Access Compliance Report

Public Rights-of-Way

(Curb Ramps)

Intersection ID: 30502	Main Street: ORCHARD_GRASS_CT	Cross Street: STONES_LANDING_ST	Location: NE
ADA ID: DB0B8FA90DC9	Ramp Type: PerpDiag	Initial Pass/Fail: Fail	Overall Compliance: No
		Severity Score: 10

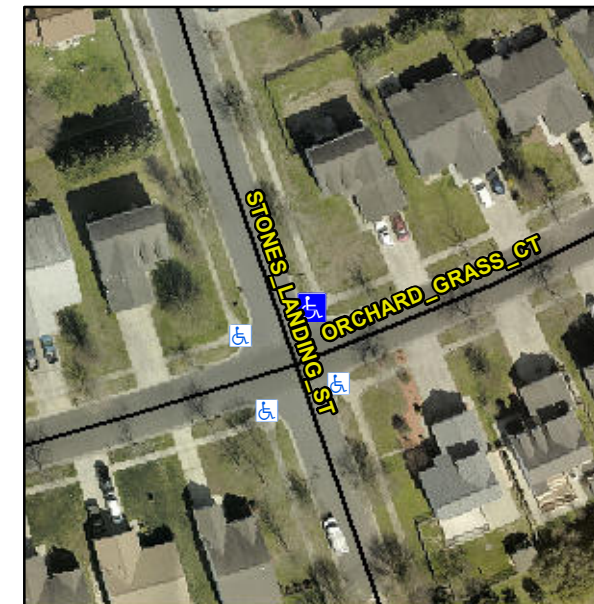
R304.5.1, R304.5.3

Compliance	Description	Data	Compliance	Description	Data
N/A	Ramp Length (in)	72.0	Yes	Ramp Slope (%)	5.2
No	Ramp Width (in)	40.5	No	Ramp XSlope (%)	2.8
N/A	Flare Type LT	N/A	N/A	Flare Type RT	N/A
N/A	Flare Slope LT (%)	N/A	N/A	Flare Slope RT (%)	N/A
N/A	Flare Traversable LT?	N/A	N/A	Flare Traversable RT?	N/A
N/A	Landing Length (in)	N/A	N/A	DWS Provided?	N/A
N/A	Landing Width (in)	N/A	N/A	DWS Contrast?	N/A
N/A	Landing Slope (%)	N/A	N/A	DWS Length (in)	N/A
N/A	Landing X Slope (%)	N/A	N/A	DWS Full Width?	N/A
N/A	Landing Curb? (Y/N)	N/A	N/A	DWS Offset (in)	N/A
N/A	Shared Landing?	N/A			
N/A	Gutter Ponding?	N/A	N/A	Gutter Slope (%)	N/A
N/A	Gutter Lip Ht (in)	N/A	N/A	Gutter X Slope (%)	N/A
N/A	Painted X Walk1?	No	N/A	Painted X Walk2?	No
	X Walk 1 Direction	To W		X Walk 2 Direction	To S
N/A	X Walk 1 Width (in)	N/A	N/A	X Walk 2 Width (in)	N/A
	X Walk 1 Slope (%)	1.3		X Walk 2 Slope (%)	3.5
	X Walk 1 X Slope (%)	0.8		X Walk 2 X Slope (%)	1.8

N/A	Ramp inside XWalk1?	N/A	N/A	Ramp inside XWalk2?	N/A
	Road Slope (%)	0.7	N/A	Clear Space?	N/A
	Road X Slope (%)	1.7	N/A	Clear Space to XWalk (in)	N/A
N/A	Any Obstructions?	N/A	N/A	Storm Grate/Utility Hazard?	N/A
	Obstruction Type			Storm Grate/Utility Type	
		N/A			N/A
		Yes		Surface Condition? (G/P)	Good

Remove & Replace Curb Ramp With Two New Directional Ramps or Equivalent.
